**Optimization Review**  
**Valley Park TCE Superfund Site**  
**Valley Park, Missouri**

Report of the Optimization Review  
Site Visit Conducted at the Valley Park TCE Superfund Site on  
24 January 2013

Final  
4 June 2013

Figure 9. Suggested Ground Water Sampling Transects on Valley Technologies Site

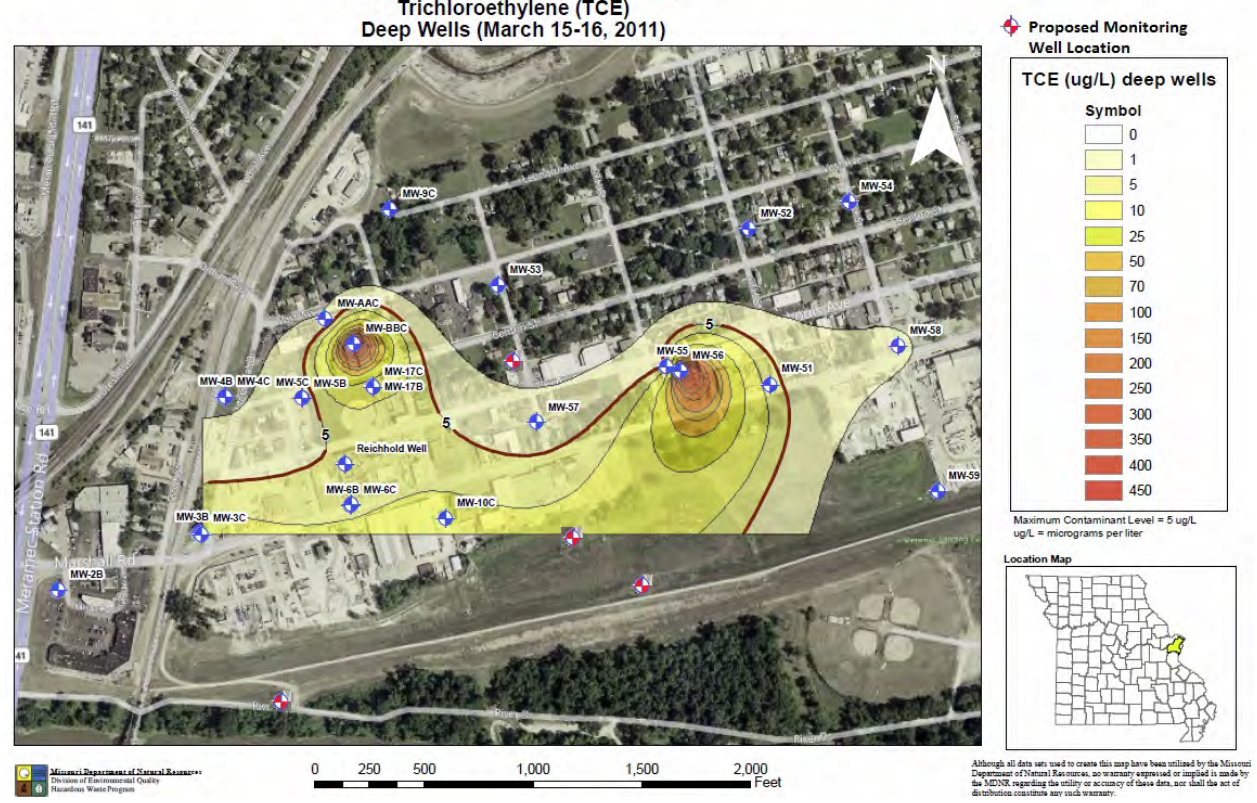
It is recommended that several ground water sampling transects be conducted to the east-northeast of the treatment plant building and within the Valley Technologies building (if possible). These profiles should consist of 4-5 sampling points separated laterally by as little as 10 feet that obtain grab samples for either on-site or expedited off-site analysis. Samples should be obtained from at least two depths; one near the low water table (say, 28-30 feet below ground surface [bgs]), and other sample 20 feet below that (to be within the MW-56 screened interval). The profiles should be conducted along north-northwest to south-southeast lines; one extending north and south from MW-56, another parallel to the west side of the Valley Technologies building, and another within the Valley Technologies building (if possible). If contamination substantially over the cleanup goals is found under the building, another line on the east side of the Valley Technologies building would be needed to confirm the extent of the contamination. Soil samples should be obtained above the water table for any boreholes within the Valley Technologies building and the location of the profile in the building should be based, to the extent possible, on the locations of equipment and piping for past vapor degreasing activities (and possibly floor drain locations). New monitoring wells would be installed in select boreholes to provide the ability to monitor the high concentrations and to possibly be used to facilitate future treatment.

An additional sampling profile of 3-4 points should be considered along the southern side of the treatment plant building to assess the contribution to the ground water plume from contamination remaining under

the alleyway. Boreholes on this profile should be spaced about 10 feet apart and also drilled to similar depths as those on the north-south profiles described above. Suggested transect locations are shown on Figure 9.
